Tennessee Valley Authority, 1101 Market Street, Chattanooga, Tennessee 37402

CNL-15-134

Watts Bar Nuclear Plant, Unit 2  
Construction Permit No. CPPR-92  
NRC Docket No. 50-391

Subject: **Watts Bar Nuclear Plant Unit 2 – Submittal of Developmental and Final Revision J of the Technical Specification & Technical Specification Bases, and Developmental and Final Revision E of the Technical Requirements Manual & Technical Requirements Manual Bases**

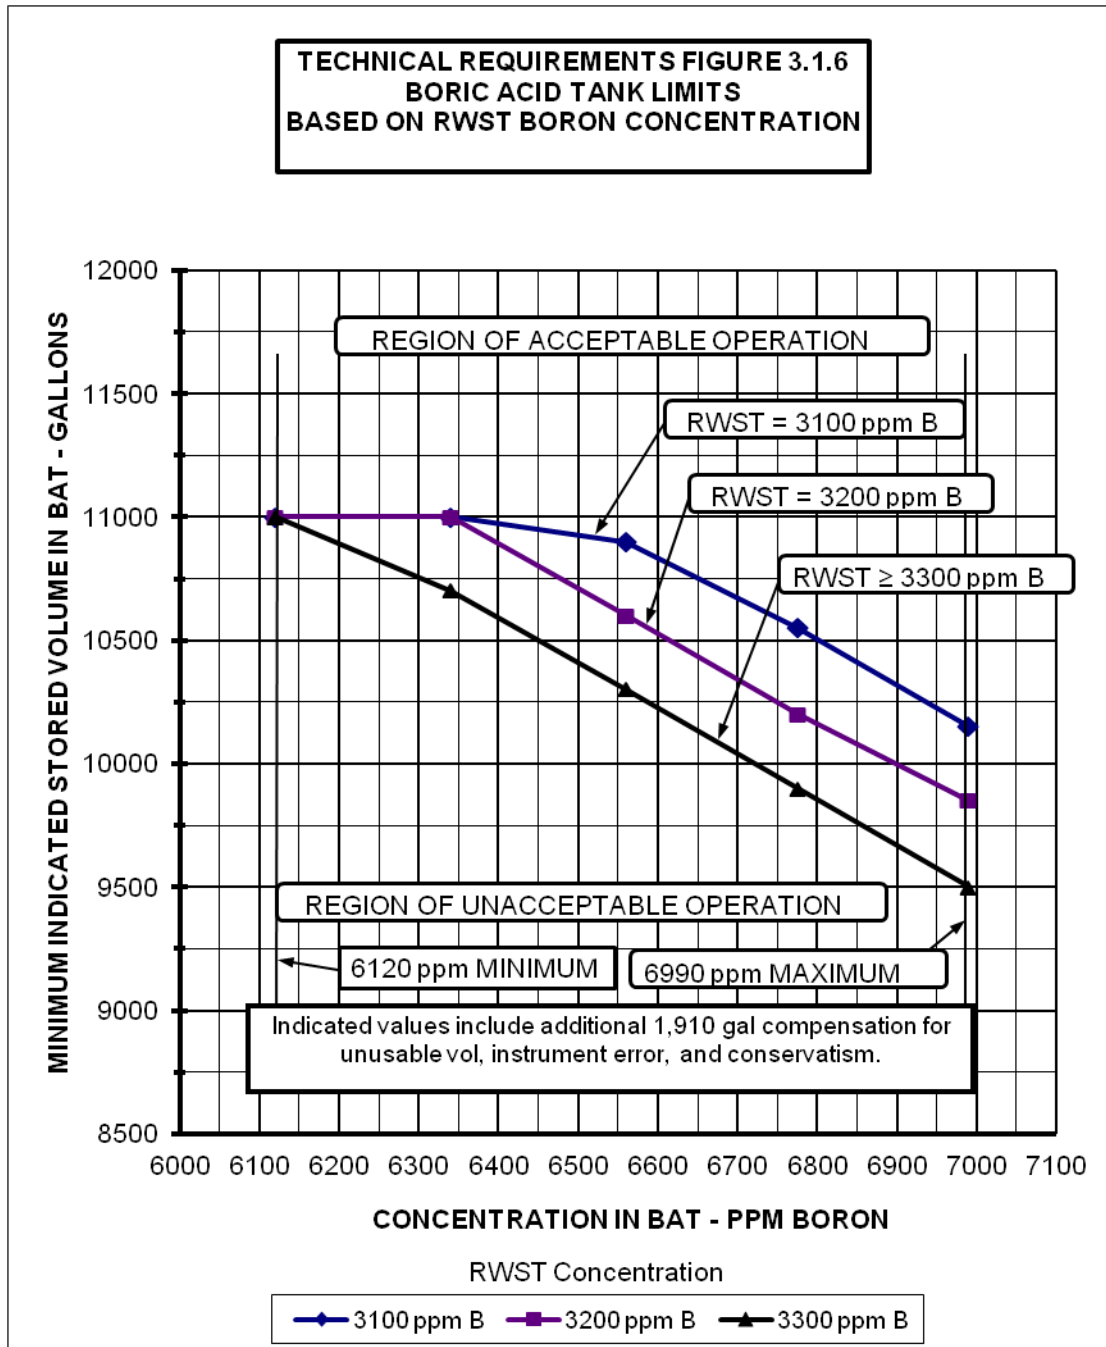
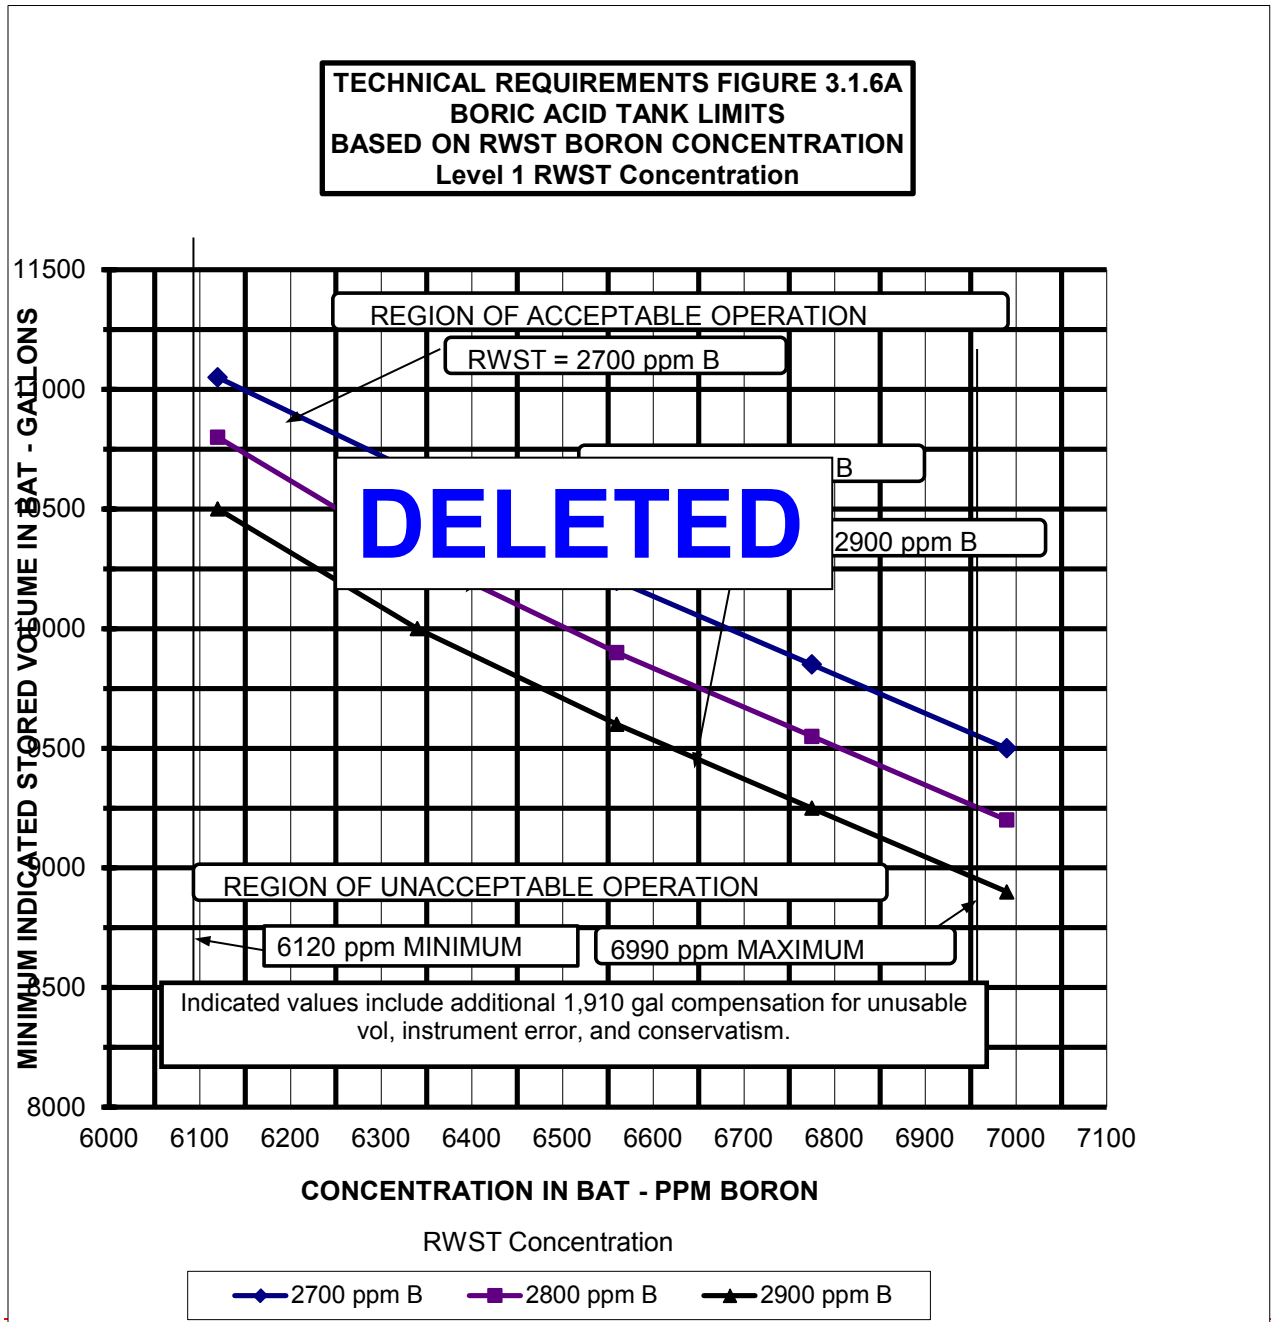
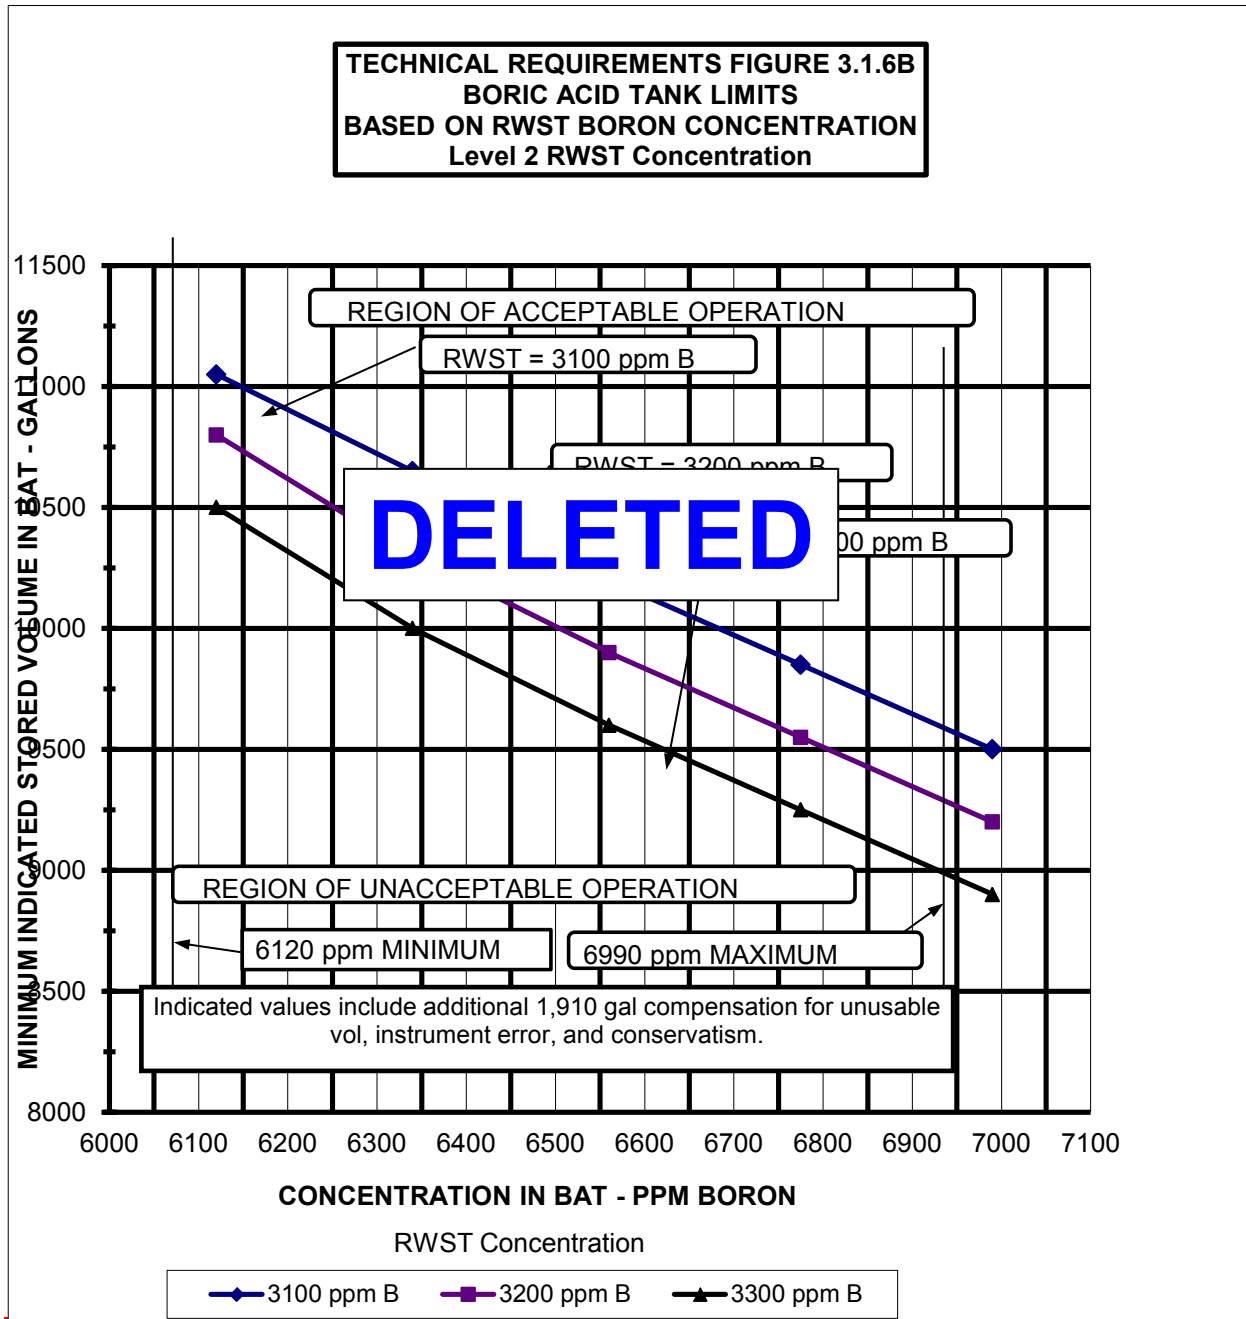
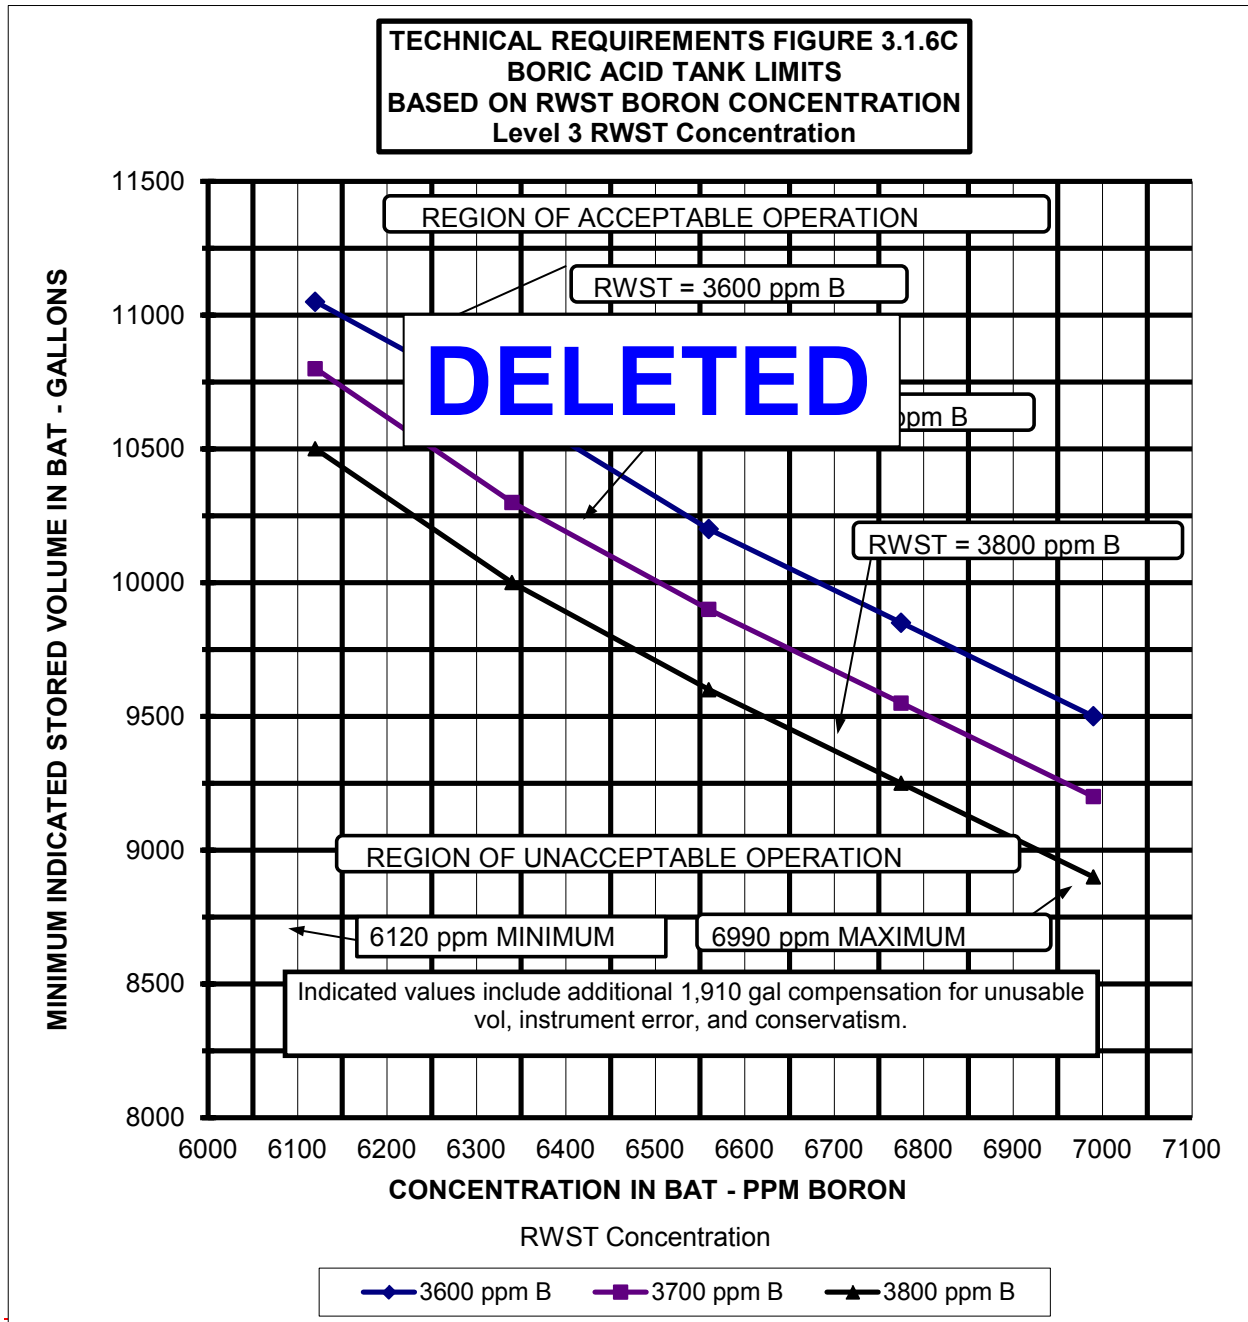
| SURVEILLANCE |  | FREQUENCY |
|--------------|--|-----------|
| TSR 3.1.6.5  | <p>-----NOTE-----<br/>Only required if the BAT is required OPERABLE.<br/>-----</p> <p>Verify BAT boron concentration is in accordance with Figures 3.1.6A, 3.1.6B, and 3.1.6C.</p>   | 7 days    |
| TSR 3.1.6.6  | <p>-----NOTE-----<br/>Only required if the BAT is required OPERABLE.<br/>-----</p> <p>Verify BAT borated water volume is in accordance with Figures 3.1.6A, 3.1.6B, and 3.1.6C.</p>  | 7 days    |

~~FIGURE 3.7.3-1~~

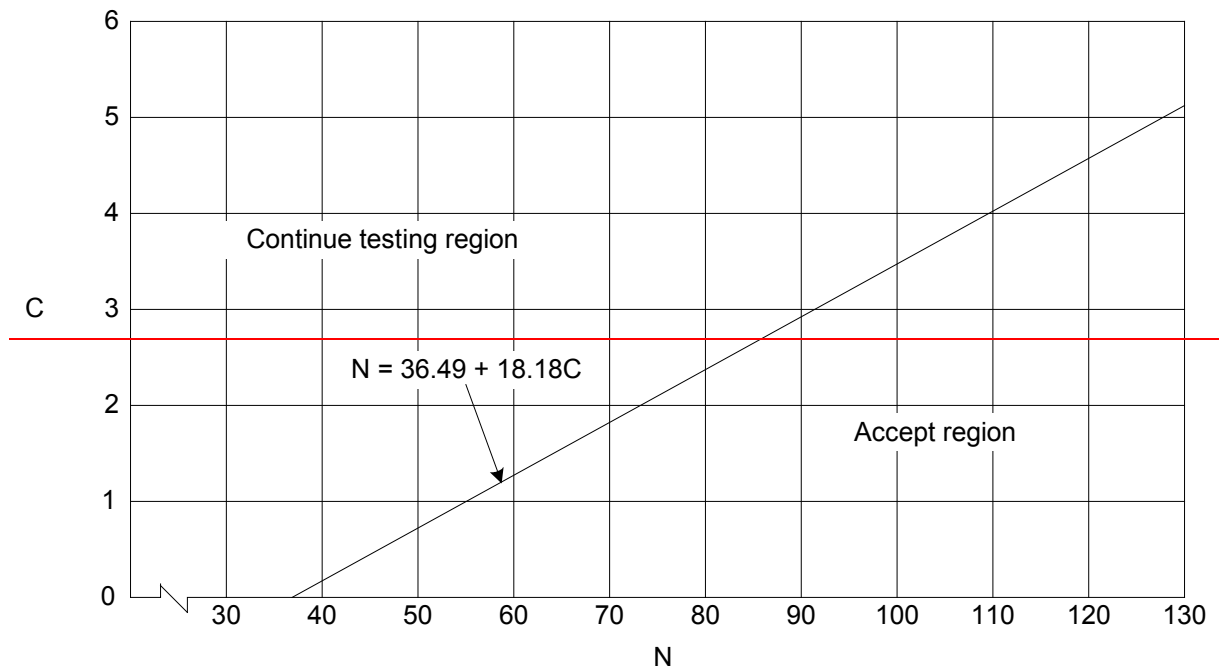
- ~~1. An initial representative sample of 37 mechanical snubbers shall be functionally tested in accordance with Figure 3.7.3-1. For each mechanical snubber type which does not meet the functional test acceptance criteria of Table 3.7.3-5, another sample of at least 19 snubbers shall be tested. The results from this sample plan shall be plotted using an "Accept" line which follows the equation  $N = 36.49 + 18.18C$  where "C" is the number of snubbers which do not meet functional test acceptance criteria. If the point plotted falls on or below the "Accept" line, testing of that type of snubber may be terminated. If the point plotted falls above the "Accept" line, testing must continue until the point falls in the "Accept" region or all mechanical snubbers have been tested.~~
